Licence to Interfere by Impounding Flow

HAZARDOUS WASTE DAM

SUBJECT: Repeal of Licence 52629

SITE NAME:- "DISUSED TAILINGS DAM"

SOUTH BLACKWATER COAL
WATER MANAGEMENT PROJECT
VOLUME OF OVERFLOW

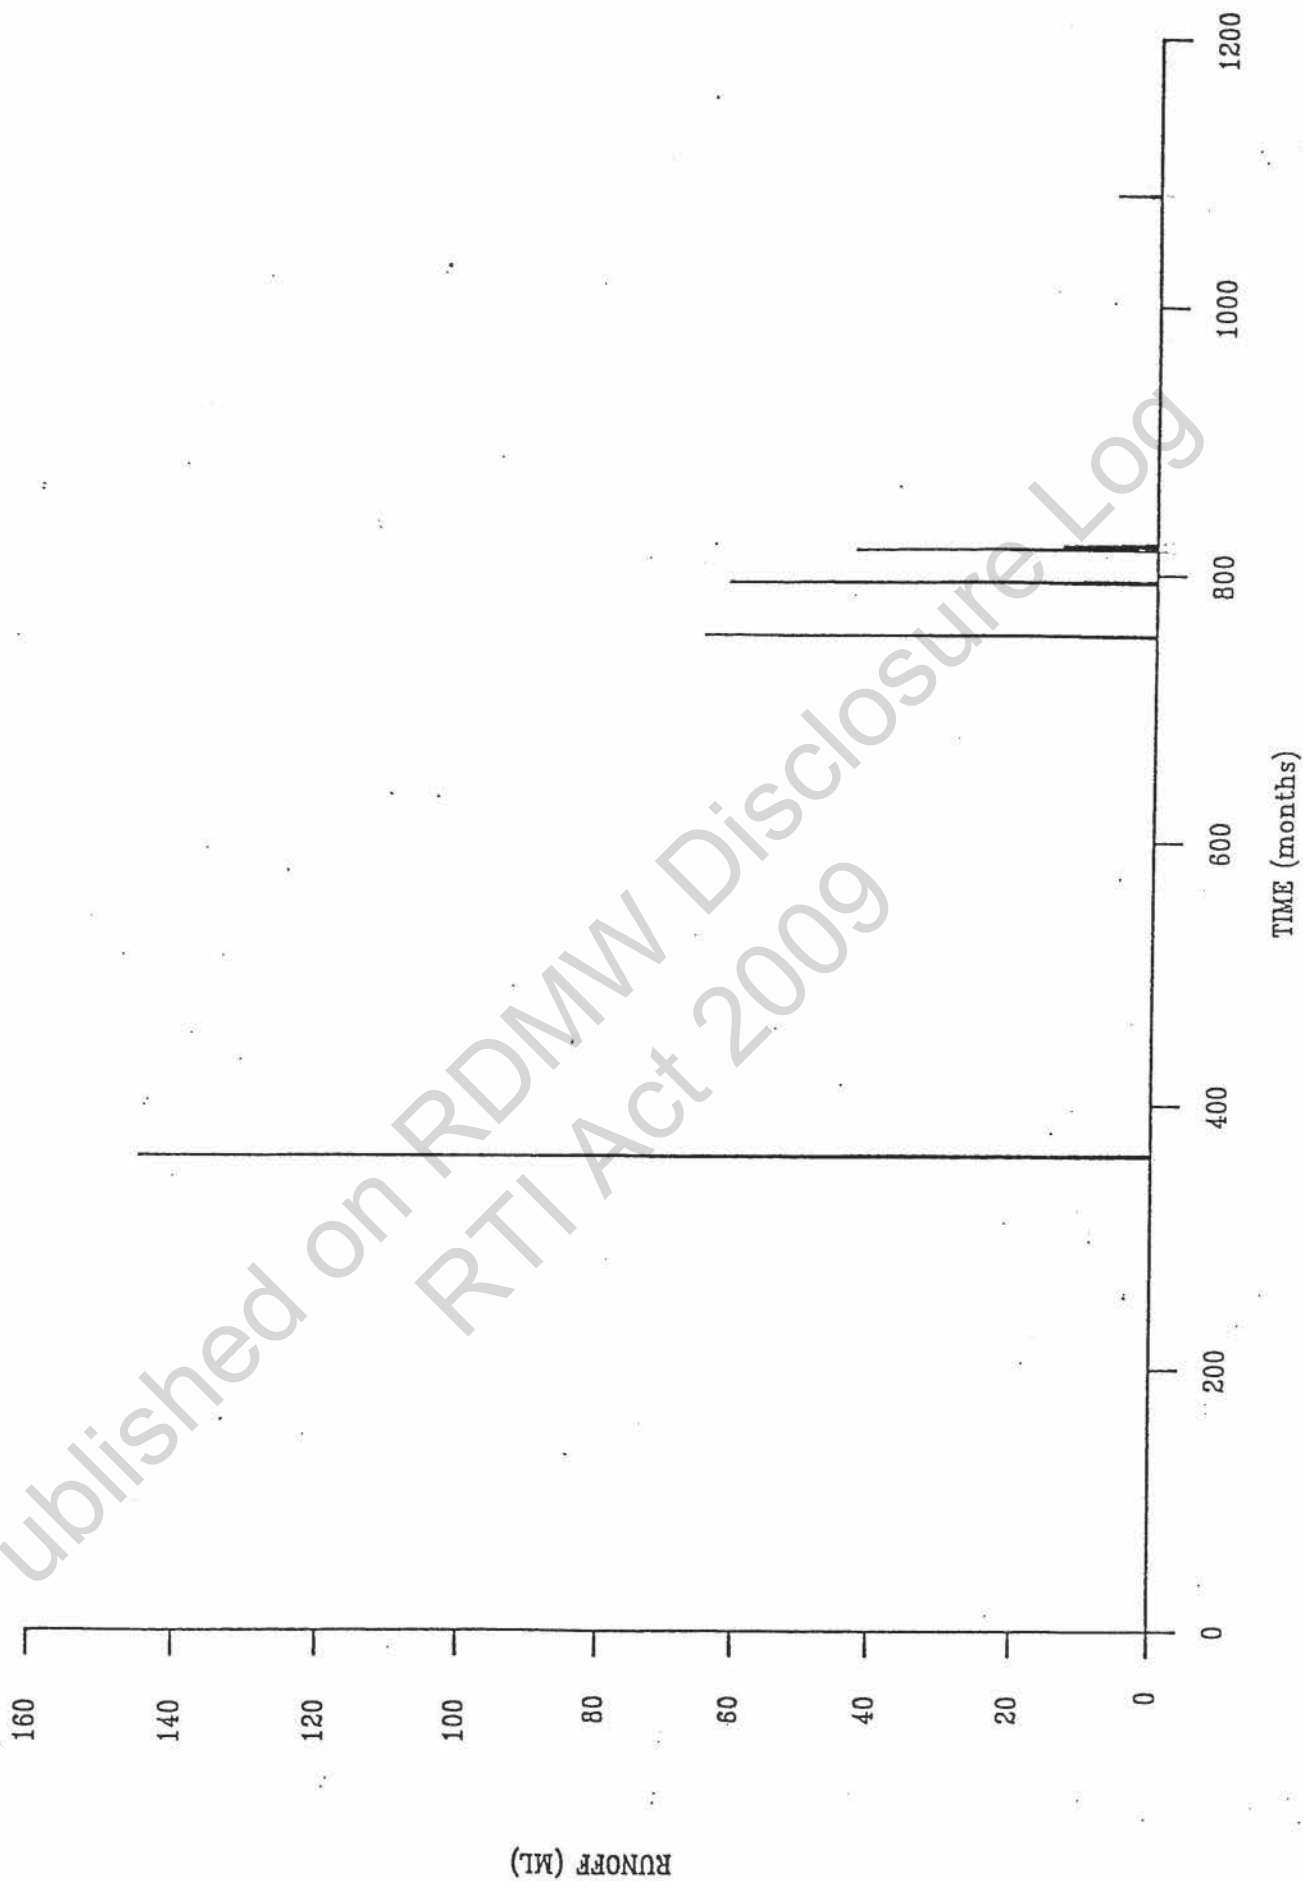
The behaviour analysis of the dam shows that on average overflow will occur approximately once every twelve years. The concept proposed includes a pumpout system at a rate of 100 ML/annum to pump from the proposed new dam into the water supply for the preparation plant. Figure 1 shows the predicted storage behaviour of the dam. Because the pumpout system maintains the dam near empty for most of the time, spill only occurs when a rainfall event causes runoff in excess of the dam's storage capacity. Figure 2 shows the volume of each overflow event which it is predicted will occur.

© COPYRIGHT BLAIN JOHNSON PTY. LTD. DRAWING NUMBER FIG 3 71 of 99 REV.
--

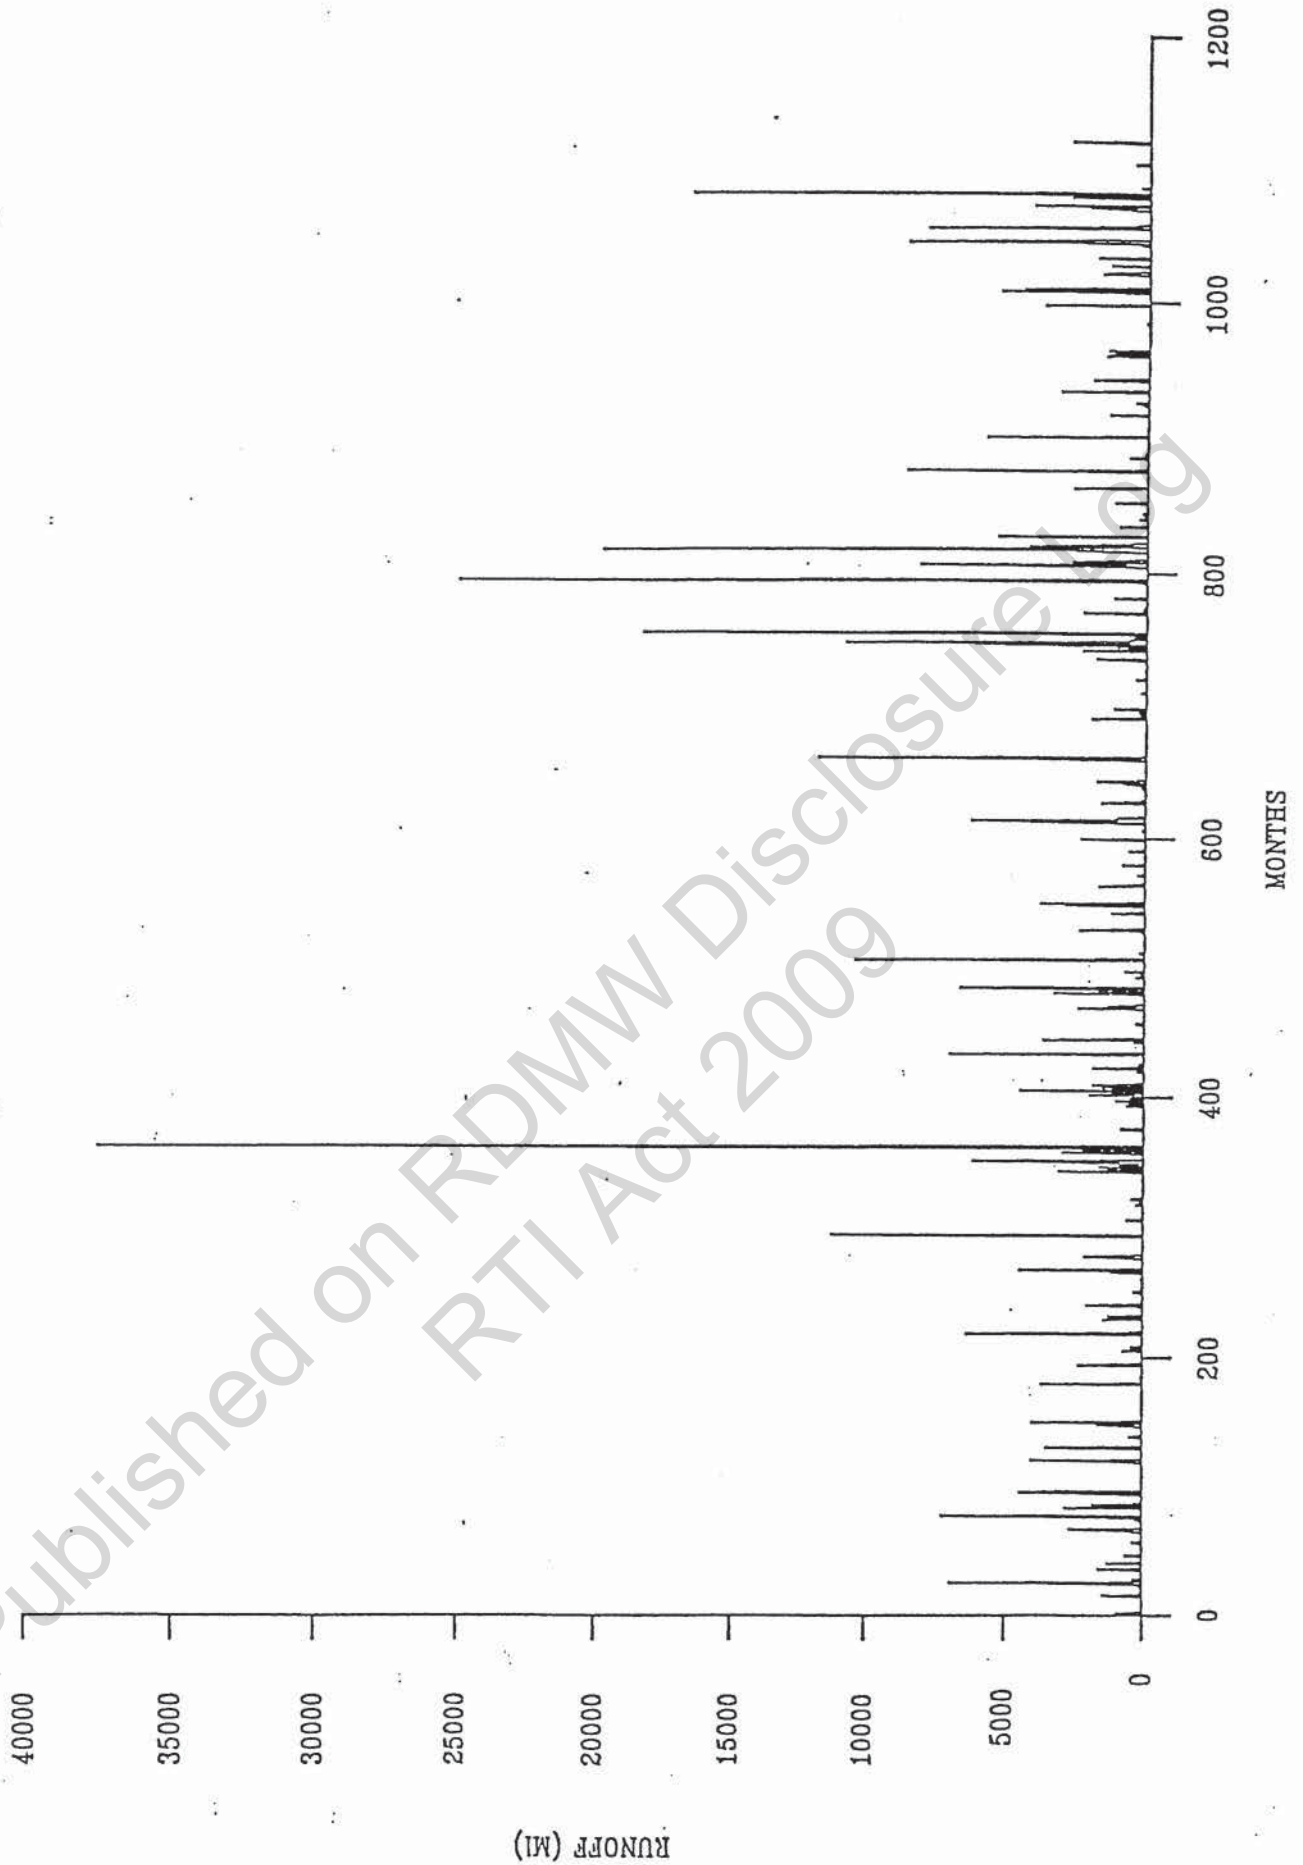
These overflow volumes have been compared with the estimated stream flow volumes in Sirius Creek downstream of the proposed new Holding Dam shown on Figure 3. The irregular flood overflows from the proposed new dam will be diluted by the larger Sirius Creek flood flows downstream. The minimum dilution rate is 1 in 200. — *GOOD SIRIUS CRK WATER DR WITH CONTAMINATED WATER.*

Figure 2- Dissed Tailings Dam  
Proposed Rehabilitated Landform

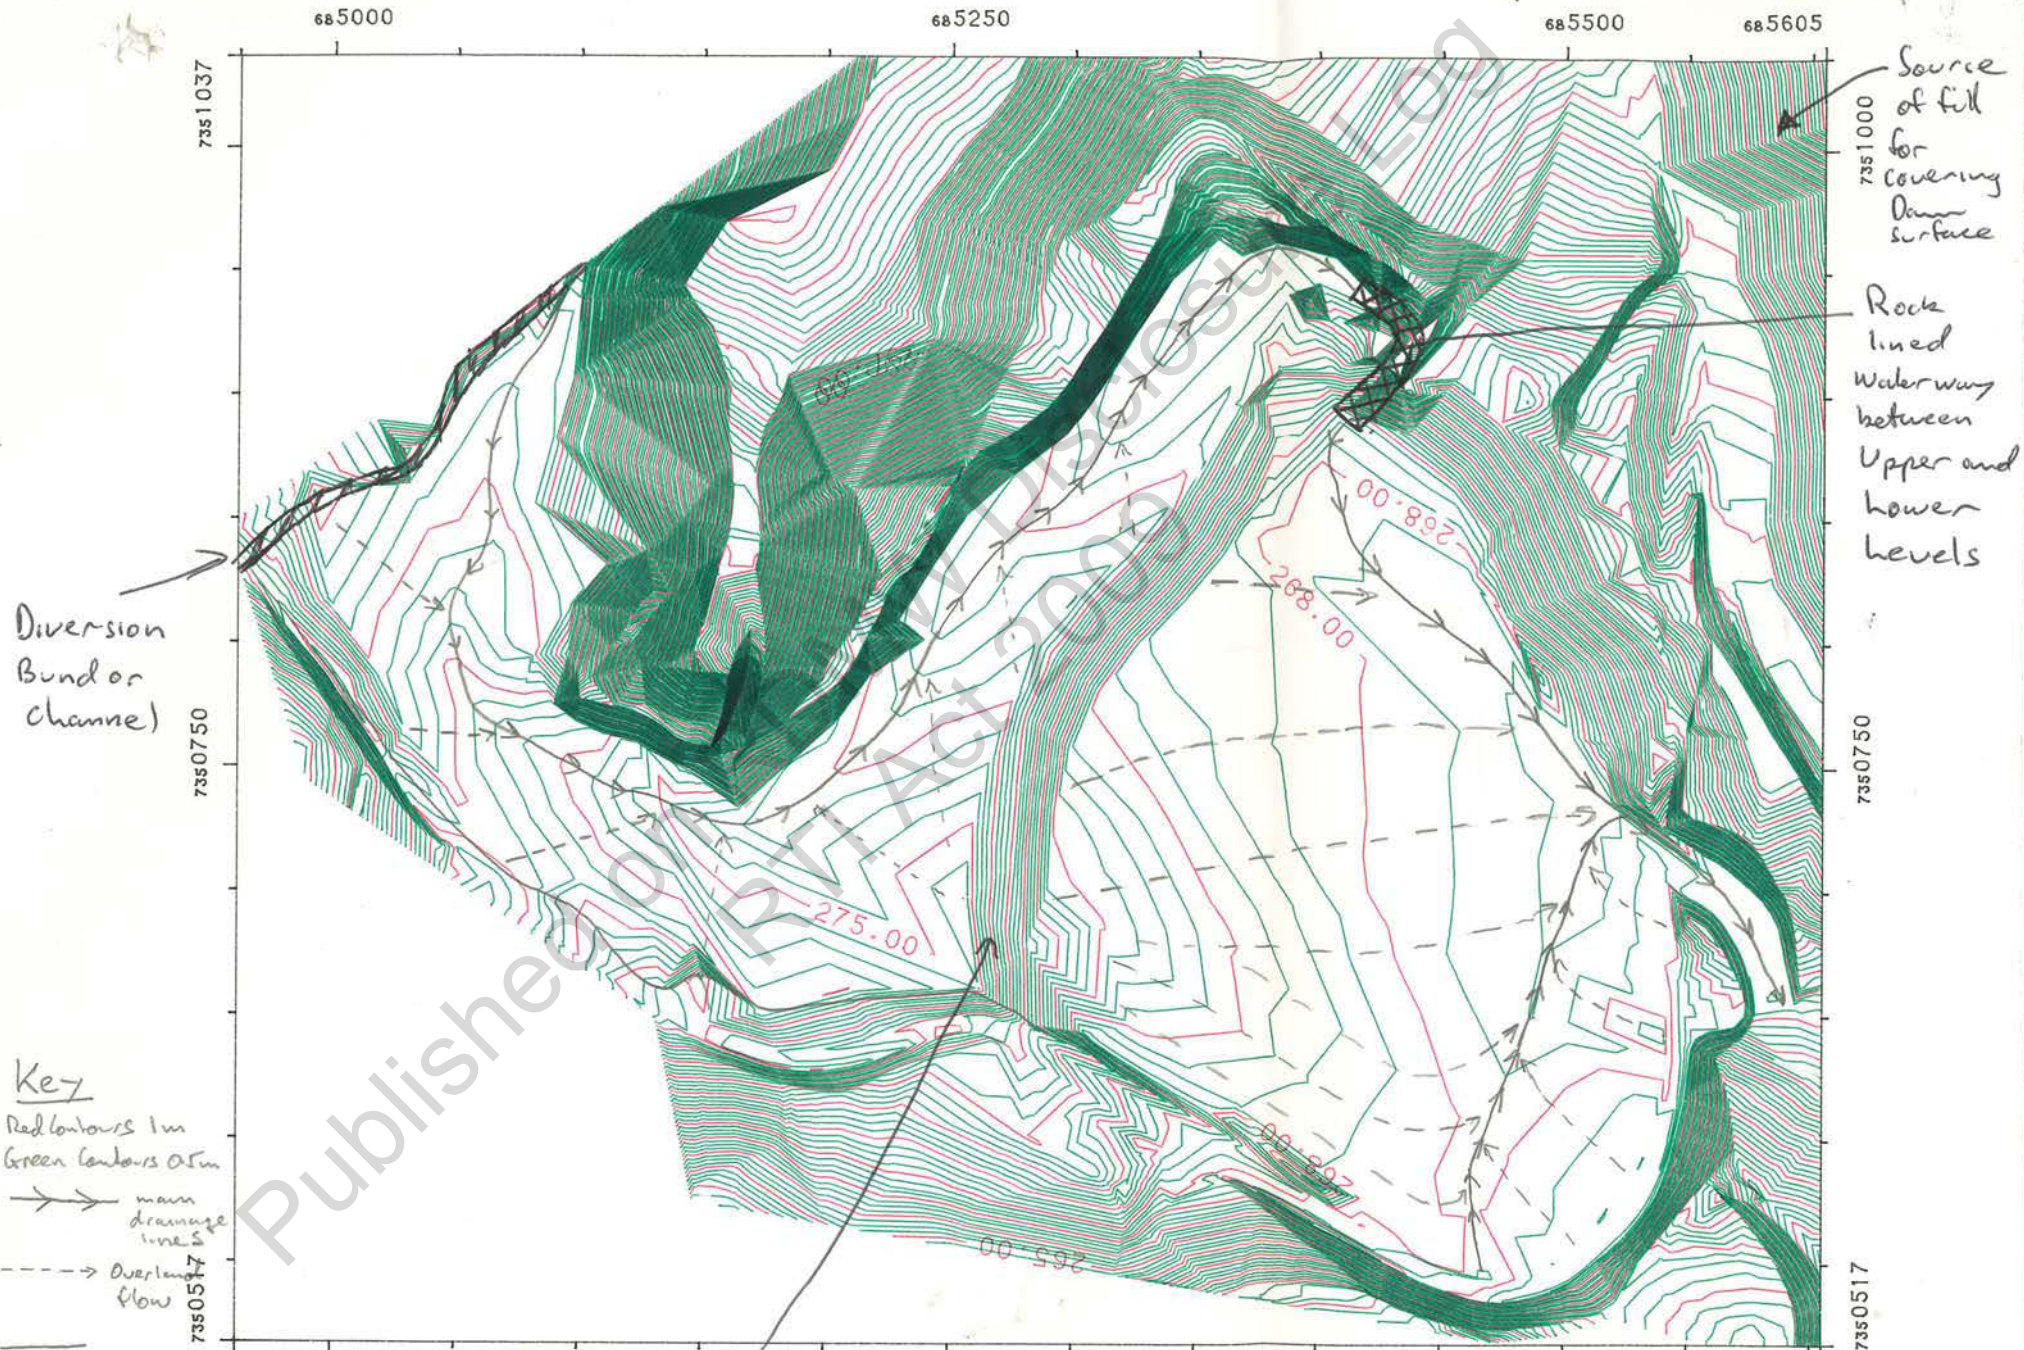
Figure 2 shows the proposed final rehabilitated landform for the both levels of the dams. The design involves the placement of 1 to 1.5m of spoil over the tailings so that all water runoff from the new surface will flow out the existing spillway without any ponding on the surface. Some minor reshaping of the tailings may be required to achieve a minimum 1m spoil cover. A 1m cover is also required to permit machinery access over the dam surface. The spoil will come from the adjacent Ramp 11 North box cut spoil pile which will be rehabilitated at the same time.

The remainder of the dam surface is designed such that there is a fall of 2 to 5% from any point into the two main drains. The drainage patterns are illustrated on Figure 2. It is proposed to leave the bleeder pipe in place to act as a sub-surface drain to intercept water which may seep through the spoil. Any seepage discharge from the bleeder pipe will collect in a pond some 50m downslope from the pipe. This pond is quite large. Significant rainfall in the catchment area of the pond would be required before it would overflow to Sirius Creek (i.e. There was still over 2m freeboard in the pond after 122mm of rain fell in November 1993). A large dilution capacity is, therefore, available.

The design details regarding capping of the tailings dam as outlined are acceptable to this Department. However, there is insufficient batters design detail to allow this Department to comment on their acceptability, to do so will require further information. In their EMOS and Plan of Operations, South Blackwater committed themselves to rehabilitating tailings dams to the following standards, to be achieved after 3 years;

Figure 1- Disused Tailings Dam  
Current hand for

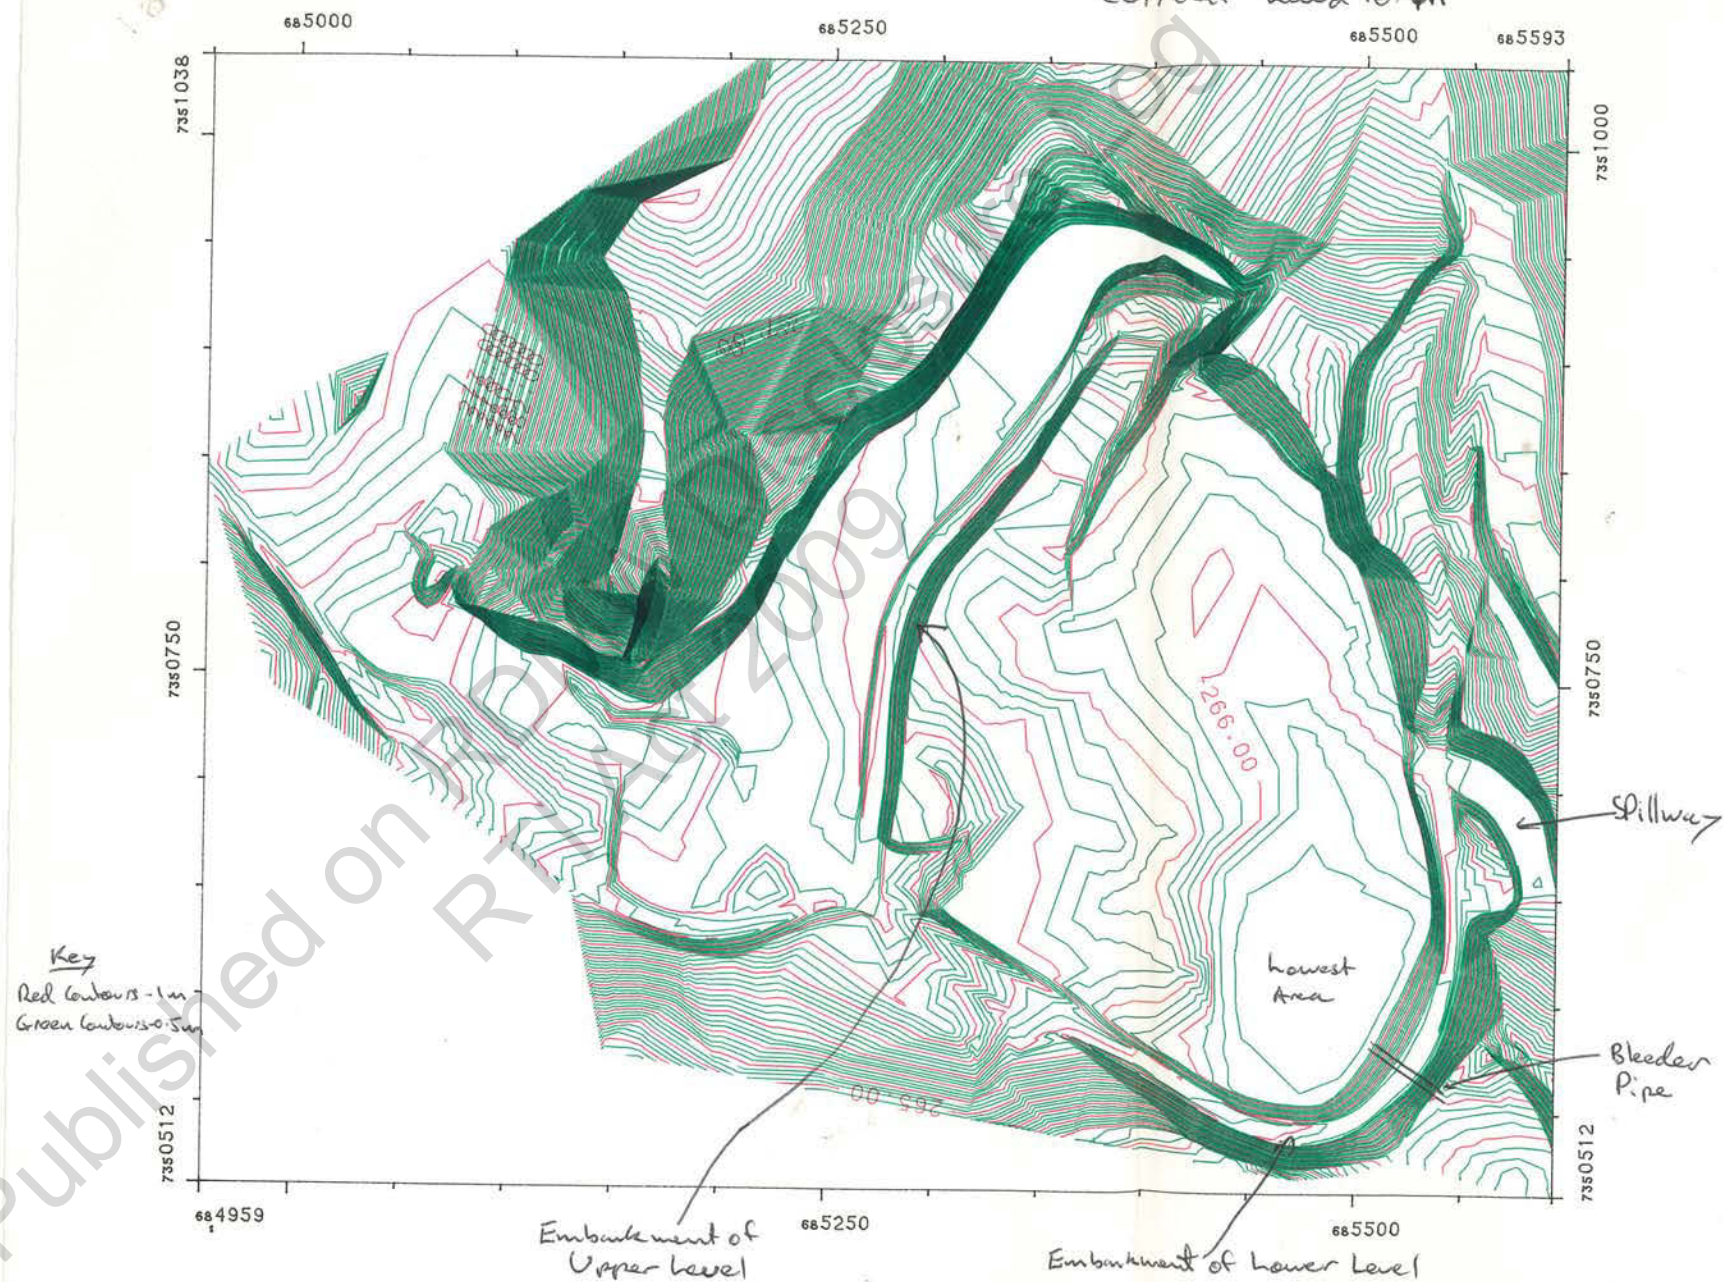
Figure 1 shows the current landform for the Disused Tailings Dam. The area to be rehabilitated consists of an upper and lower level each with an associated embankment. Figure 1 also shows the location of the low level bleeder pipe and the spillway.
